Some numerical elements for Upstream discussion

M. Gouzevitch.R&D and longevity for RPC

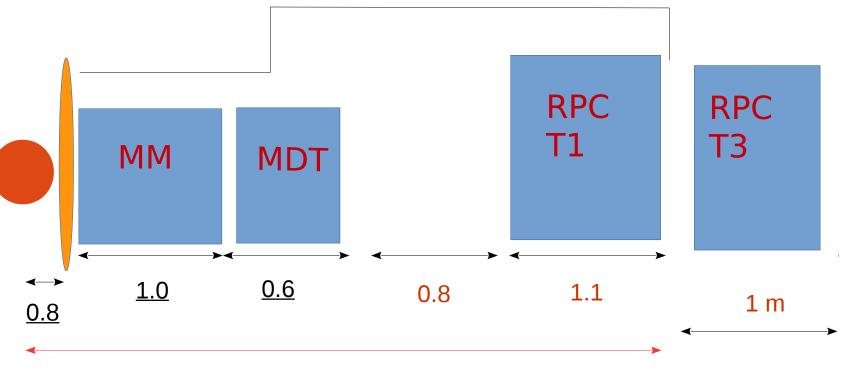
What are the upstream part of MM trolley? Depending on your plans couldn't we gain there 30 cm?

2) 2nd week

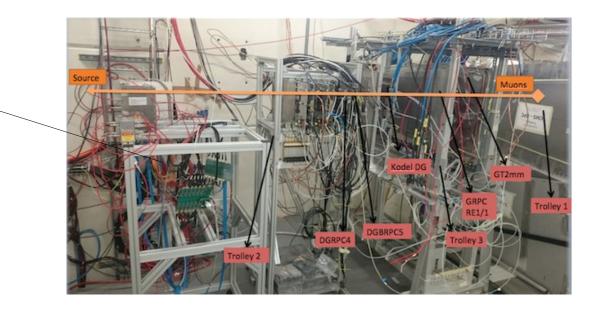
Is it the MDT stand?
